**PLEASANT PRAIRIE PLAN COMMISSION MEETING
VILLAGE HALL AUDITORIUM
9915 39th AVENUE
PLEASANT PRAIRIE, WISCONSIN
6:00 P.M.
MARCH 23, 2015**

- A. **PUBLIC HEARING AND CONSIDERATION OF PLAN COMMISSION RESOLUTION #15-06 FOR THE FOLLOWING COMPREHENSIVE PLAN AMENDMENTS** for the request of Leah Berlin on behalf of Kwik Trip, Inc. related to the proposed development of a Kwik Trip to be located at the southwest corner of STH 50 and CTH H: 1) to amend the Village 2035 Land Use Plan Map 9.9 to remove the urban reserve land use designation from the property identified as Tax Parcel Number 91-4-122-081-0010 to ensure that both the Zoning Map and the Comprehensive Land Use Plan are consistent; and 2) to update Appendix 10-3 of the Village of Pleasant Prairie Wisconsin, 2035 Comprehensive Plan to reflect the above noted changes to the 2035 Land Use Plan Map 9.9.

- D. **PUBLIC HEARING AND CONSIDERATION OF A CONDITIONAL USE PERMIT INCLUDING SITE AND OPERATION PLANS AND DIGITAL SECURITY IMAGING SYSTEM AGREEMENT AND ACCESS EASEMENT** for the request of Leah Berlin on behalf of Kwik Trip, Inc. related to the proposed development of a Kwik Trip to be located at the southwest corner of STH 50 and CT

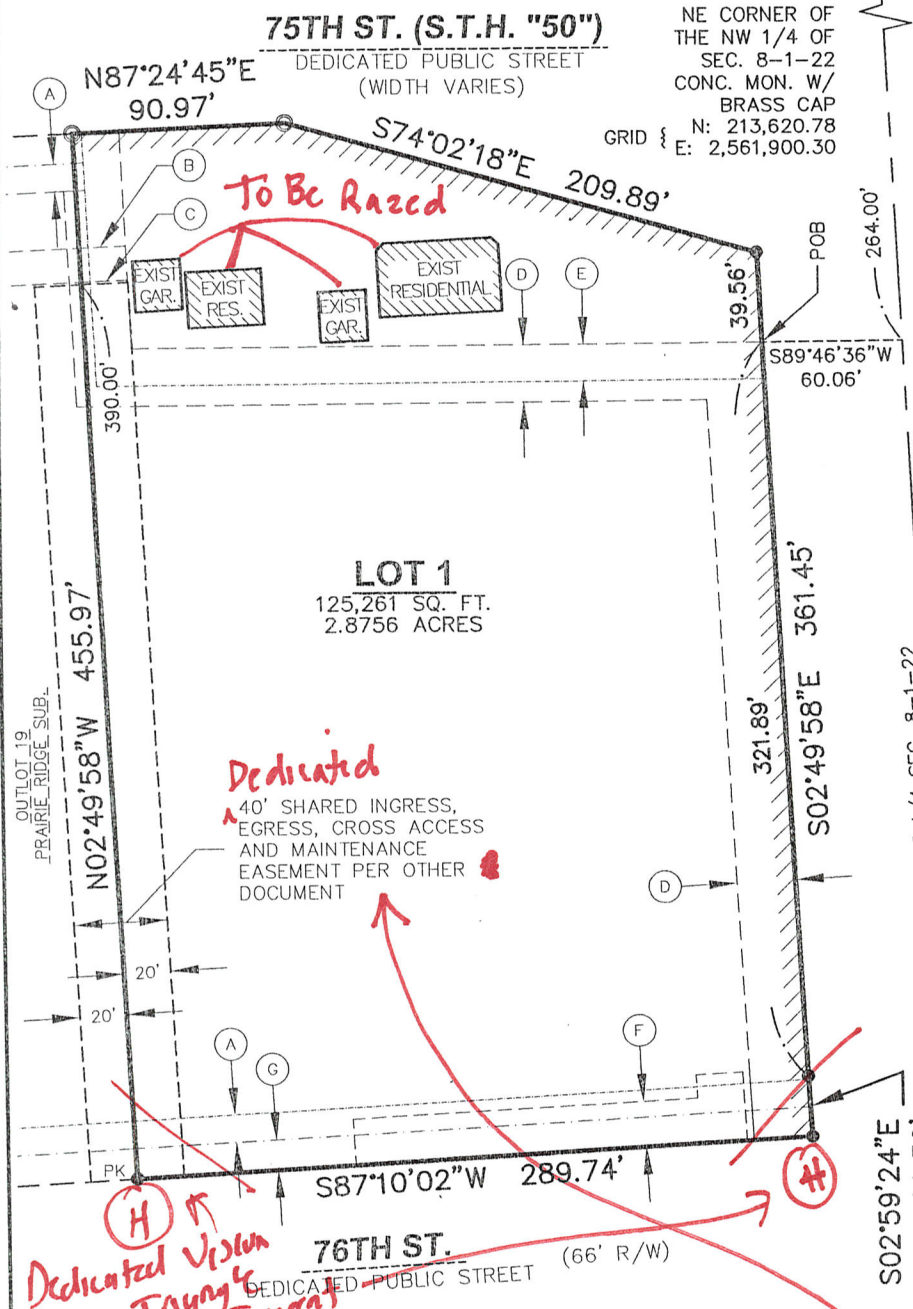
Label that the "Existing Residential, garage and other structures and pavement to be razed/removed."

DRAWN BY JSK/RWI
 SCALE
 JSD PROJ. NO. 14-6612A
 DATE 02-15-2015
 SHEET 1 OF 22

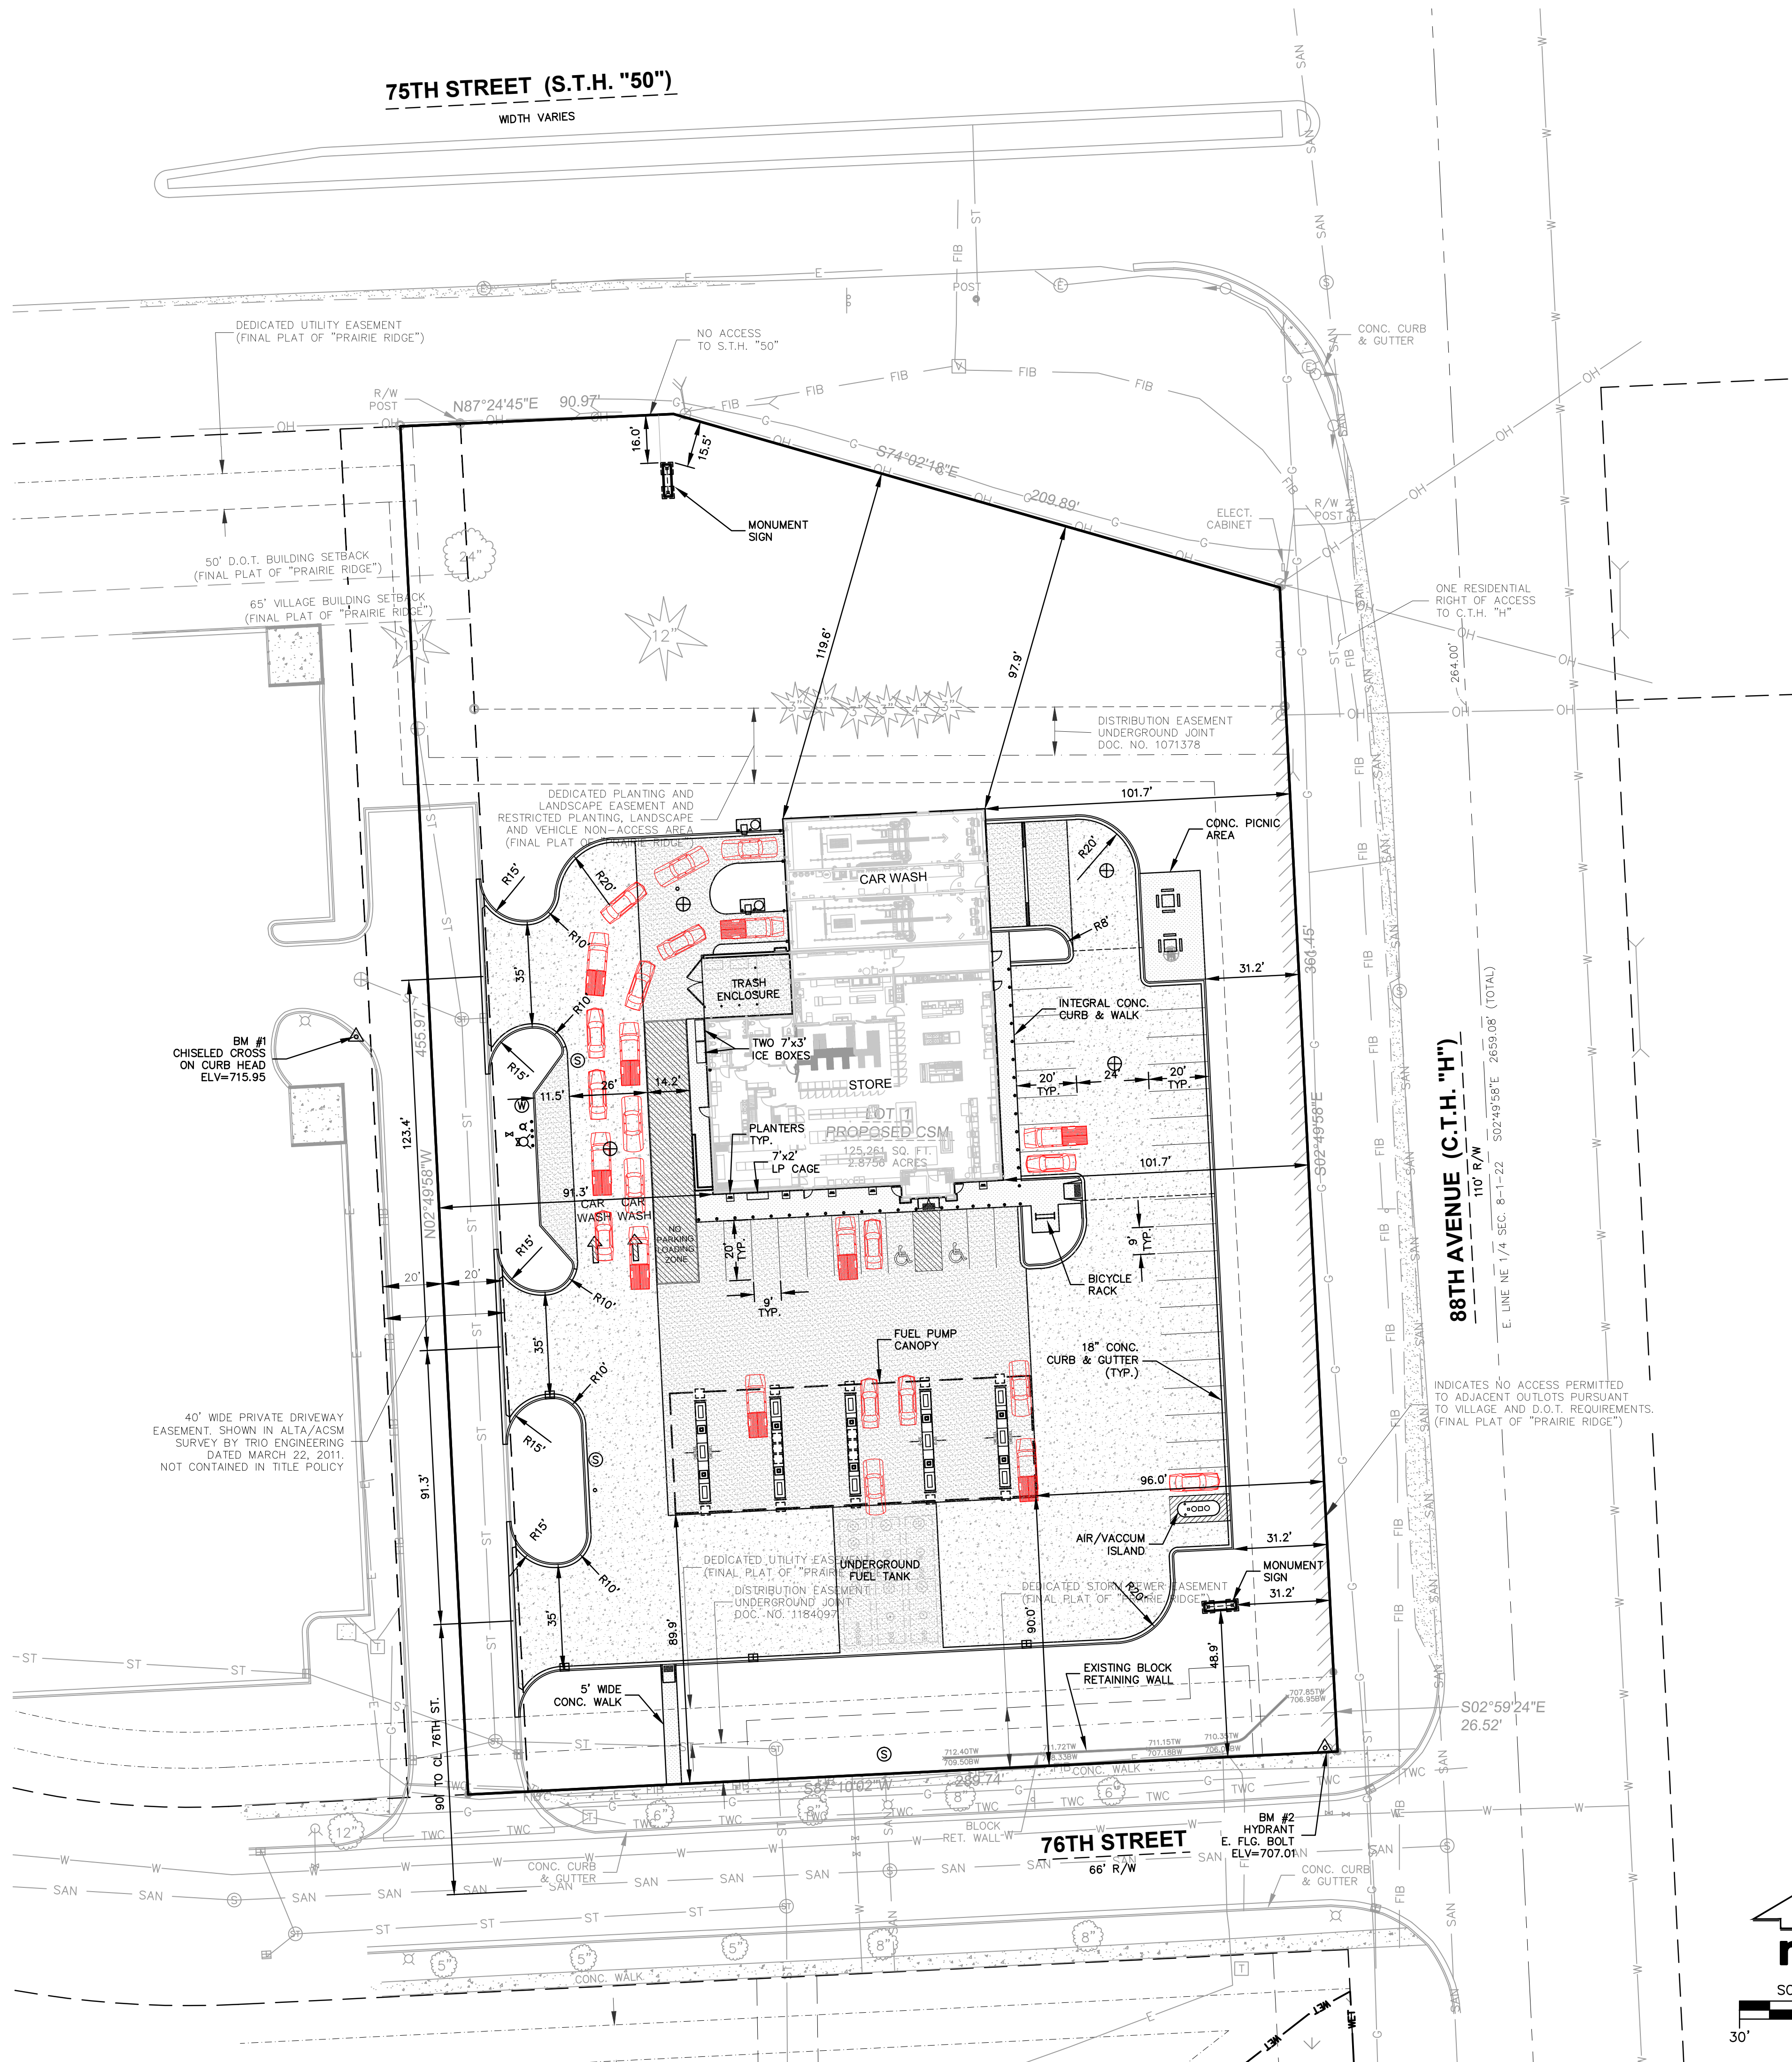
- f. Modify Plan Sheet 1:
- i. Change out the elevation shown to reflect the corrected Prairie Ridge store elevation (see changes).
 - ii. Correct the mailing address for Craig Roepke – Phone: 262-694-8027 Address: 8044 88th Avenue.

DRAWN BY: JSK/RWI
 SCALE: 1" = 30'
 JSD PROJ. NO.: 14-6612A
 DATE: 02-15-2015
 SHEET: 2 OF 22 SP1.0

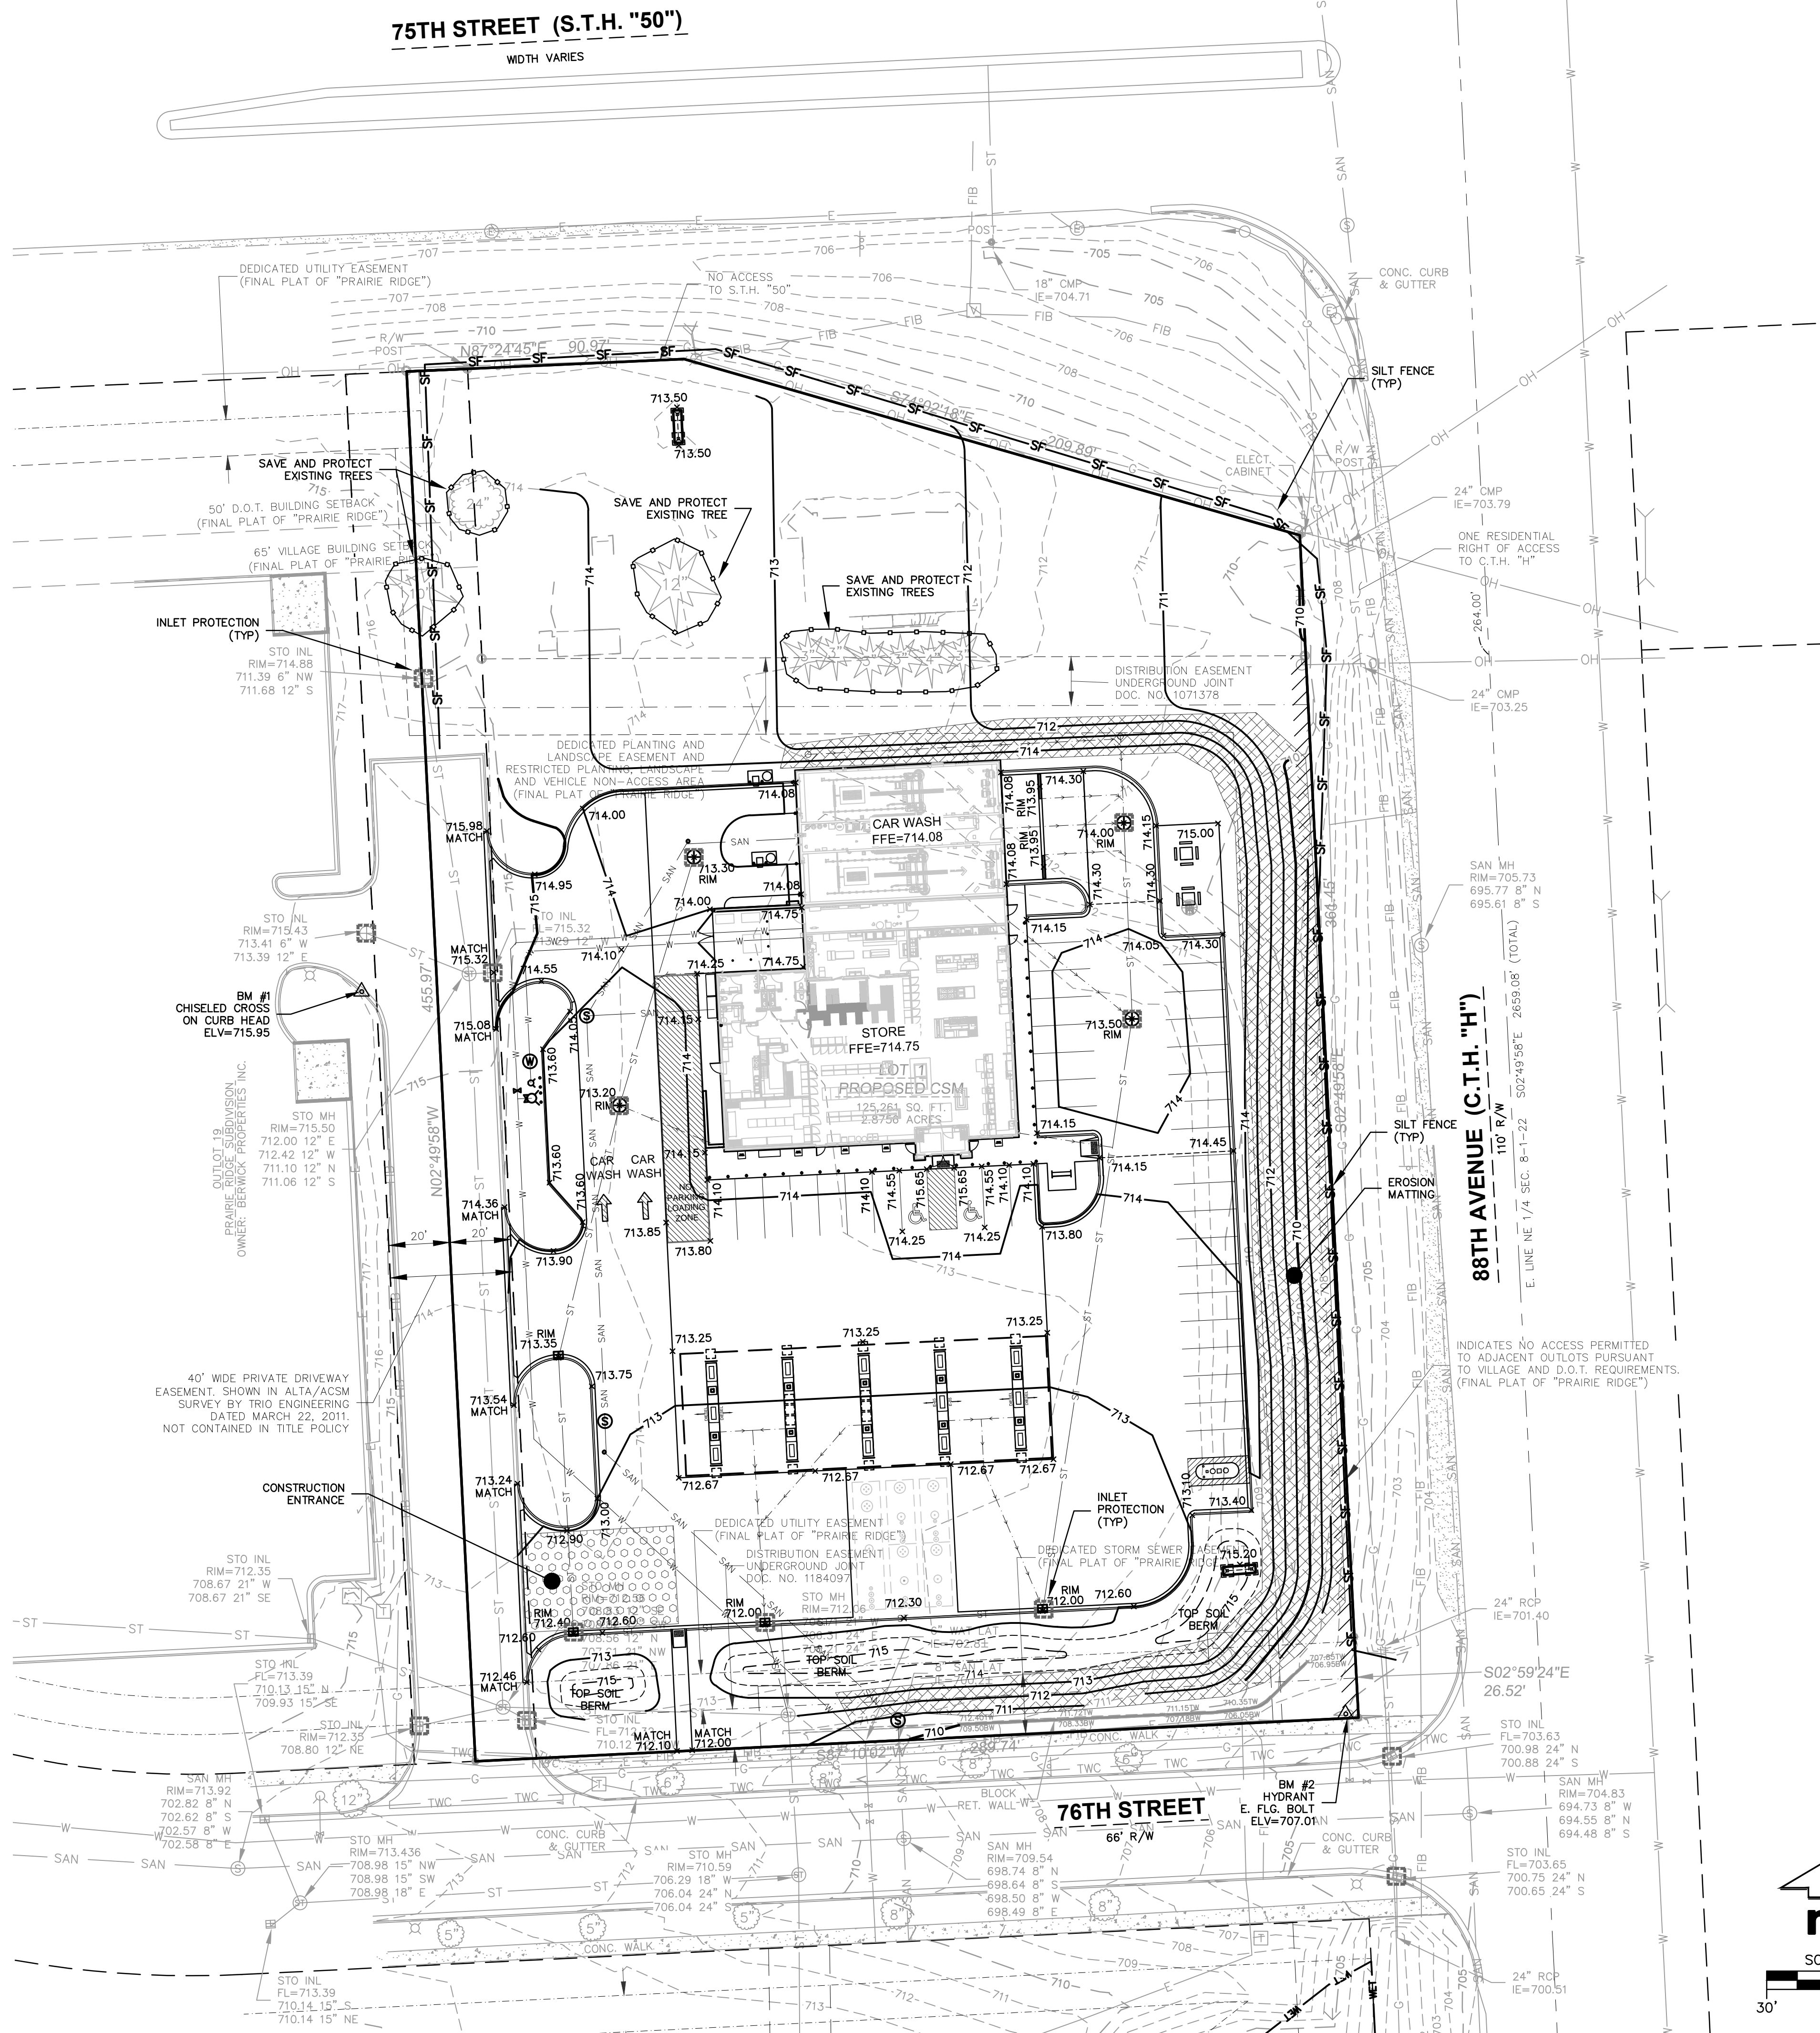
- iii. On the *Site Layout and Pavement ID Plan (Sheet SP1.0)* revise Paving Note #2 to utilize the current edition of the State Highway Specifications.
